# Product Change Notification

**Product Change Notification:** PCN-22-152506

PRODUCT GROUP DRAWING FOR Tabellenzeichnung fuer AMP MCP 2.8

CD 1355036 Rev. J14

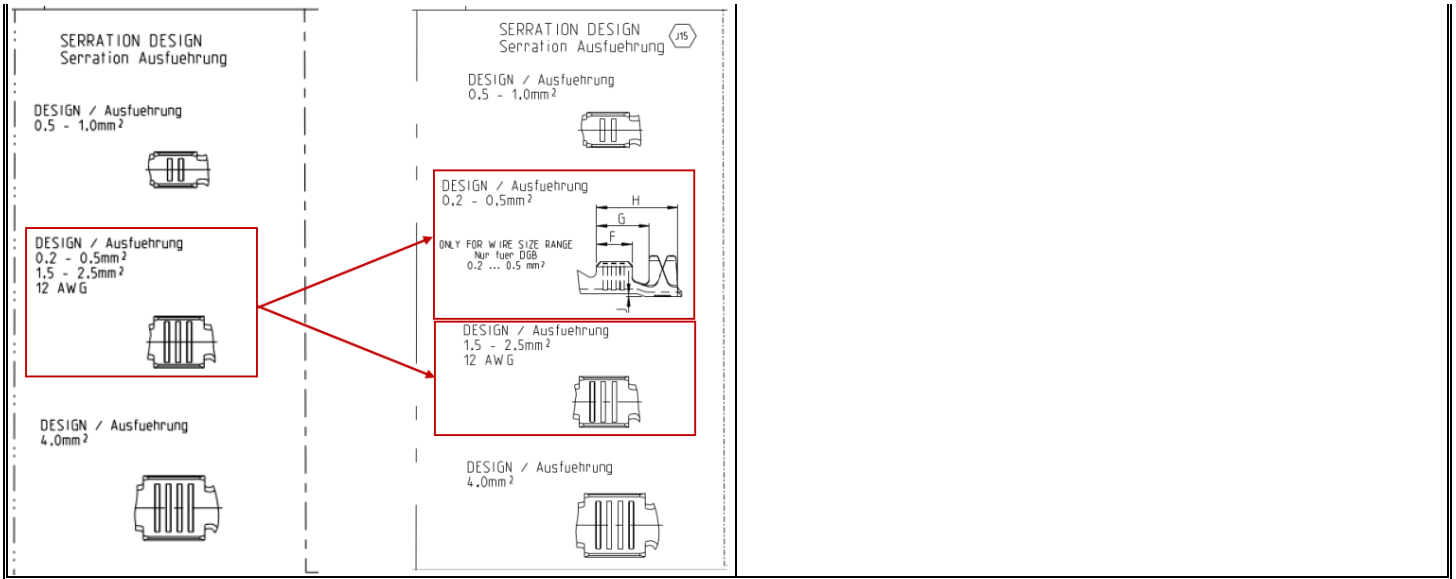
No Form Fit Function Change. Further PCN P-20-018820 was written on 23MAR2020 with the following explanation: Standardization of the silver material for the AMP MCP 2.8. The Plating has changed in the connection area from Ag to Sn (state of the art for connection areas). The base material and the plating in the contact area remain the same. AMP MCP 2.8 Revision E revised to Rev F for all silver variants, except PN 1-2141857-3 and PN 1-2141859-3, revised from Rev A to Rev B. Please also take a look at former PCN P-20-018820 from 23MAR2020. Now we adapted the part change to the drawing.
